RESOLUTION

R188 – 2024

Certificate of Appropriateness for work in the Historic Districts: 953 W Turner, 1651 Linden

**Historical Architectural Review Board
COA Preliminary Review Sheet**

Front Elevation (Applicant)

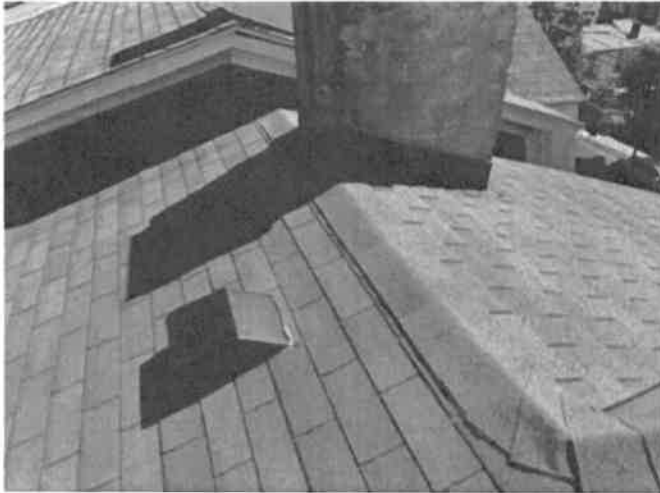
Observations & Comments: The proposed replacement of low-slope roofing at the rear is an in-kind replacement of an existing EPDM system, and it is not visible from the public right-of-way. The main shingle roof has existing 3-tab shingles and the proposal is to replace the shingles with GAF Slateline Weathered Slate shingles. In the submitted scope of work, the rear low-slope roof work list includes “replace the shingles on the mansard.” More information would be helpful to clarify this work item, namely, confirmation if the replacement shingles on the mansard will be GAF Slateline to match the main roof, as specified in the “upper main roof” scope of work. GAF Slateline is an appropriate shingle replacement product.

- The mansard roofing will not be replaced; the bottom two rows of existing mansard shingles will be removed to terminate the replacement EPDM roof on the low-slope portion, and the shingles will be reinstalled.
- The replacement GAF Slateline shingles will only be installed on the main roof at the third floor.
- EPDM will be installed on the 2nd floor roof low-slope roof.

Mr. Hart made a motion to rescind his previous motion and made a new motion to approve the application presented on October 7, 2024 for replacement of roofing at 1651 Linden Street with the condition that the new roof material is in a color that is consistent within the context of the neighborhood and surrounding structures. Compliance was found with Guidelines for Historic Districts: Chapter 3, Section 3.1- Roofs and there were no circumstances unique to the property.

Existing Main Shingle Roof (Applicant)

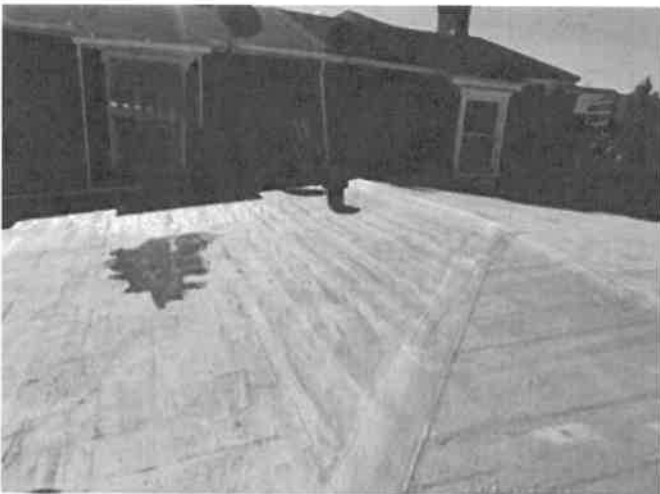
Mr. Jordan noted that he has no issue with the proposed GAS Slateline shingle replacement on the third floor roof. The Board had no opposition to the proposed replacement product.
